DESCRIPTION OF DIFFERENCES

Name of Appliance : Cordless Phone
 SIMILAR Model No. : KX-TGU11x (Base Unit)
 BASIC Model No. : KX-TGU43x (Base Unit)

Name of Appliance : Cordless Phone
 SIMILAR Model No. : KX-TGUA10 (Portable Unit)
 BASIC Model No. : KX-TGUA40 (Portable Unit)

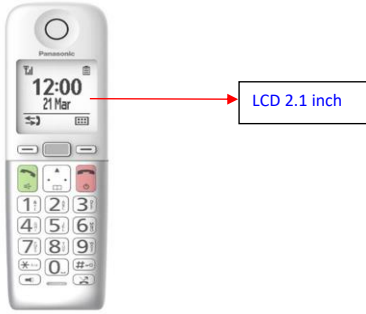
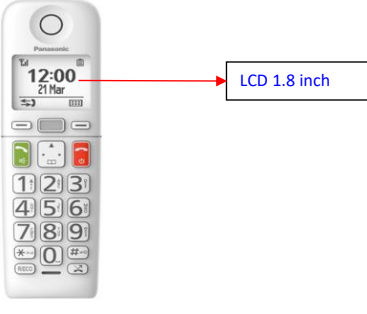
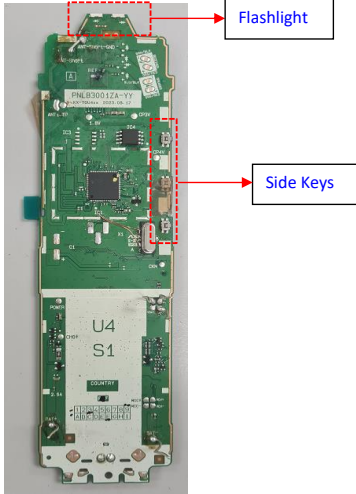
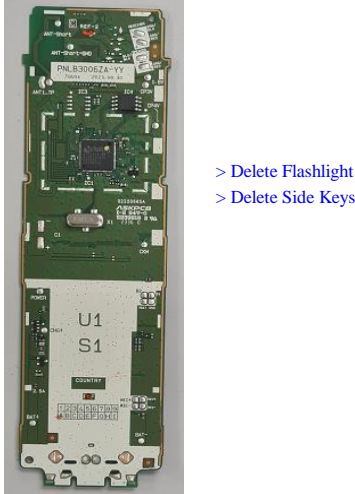
BASIC MODEL KX-TGU43x (with TAM)	SIMILAR MODEL KX-TGU11x (without TAM)
Appearance		
Inside Structure & PCB	 <p style="text-align: right; margin-right: 50px;">Answering Machine IC</p> <p style="text-align: right; margin-right: 50px;">Parallel wire</p> <p style="text-align: center; margin-top: 20px;">Operational P.C.Board with 7-Segment part</p>	 <p style="text-align: center; margin-top: 20px;"> > Delete answering machine IC. > Delete parallel wire > Delete P.C.Board </p>
P.C. Board	PNLB2999	
AC Adaptor	PNLV226

- (1) The models, KX-TGU43x and KX-TGU11x are identical in 1.9GHz RF circuit, Baseband IC and antenna.
- (2) Both models have the same P.C. Board PNLB2999.
- (3) Both models use same AC adaptor PNLV226.
- (4) The difference between both models is Answering Machine function.
 KX-TGU43x : with TAM KX-TGU11x : without TAM
